Deicorp Projects (Tallawong Station) Pty Ltd

Road Safety Audit Report Construction Stage

Tallawong Station Precinct South

May 2020

Date: 16/04/2020 **Author:** ARON JAGGANNATH **Project:** TALLAWONG STATION PRECINCT SOUTH - TCP
Comments:
BASED ON TCP 195 OF RMS'S TRAFFIC CONTROL AT WORK SITES
CARD NUMBER: 0052035594
AERIAL PHOTOGRAPHY SOURCE: NEARMAP

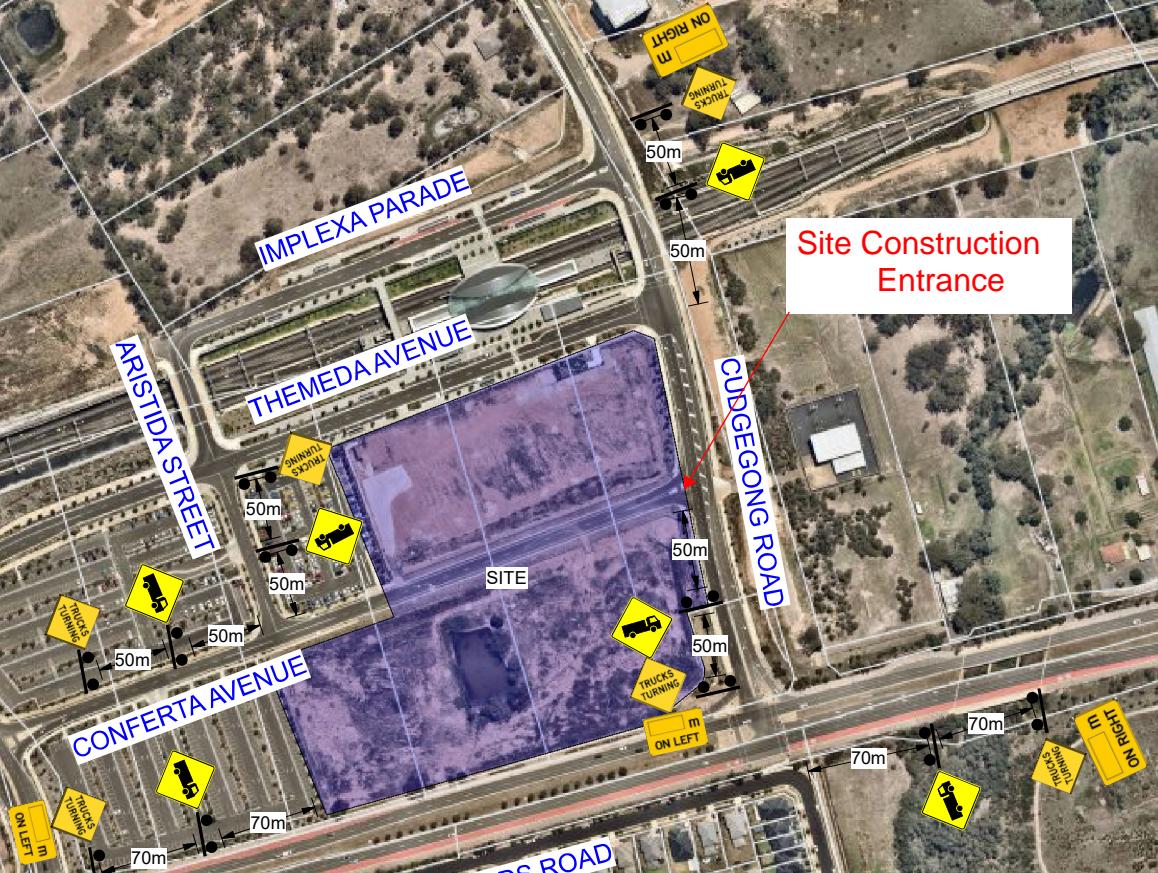
NOTE: IT IS RECOMMENDED THAT TRAFFIC CONTROLLERS STOP PEDESTRIAN MOVEMENTS ACROSS CONFERTA AVENUE BETWEEN ARISTIDA AVENUE AND TALLAWONG ROAD WHILE HEAVY VEHICLES ARE EXITING THE SITE ALONG CONFERTA AVENUE
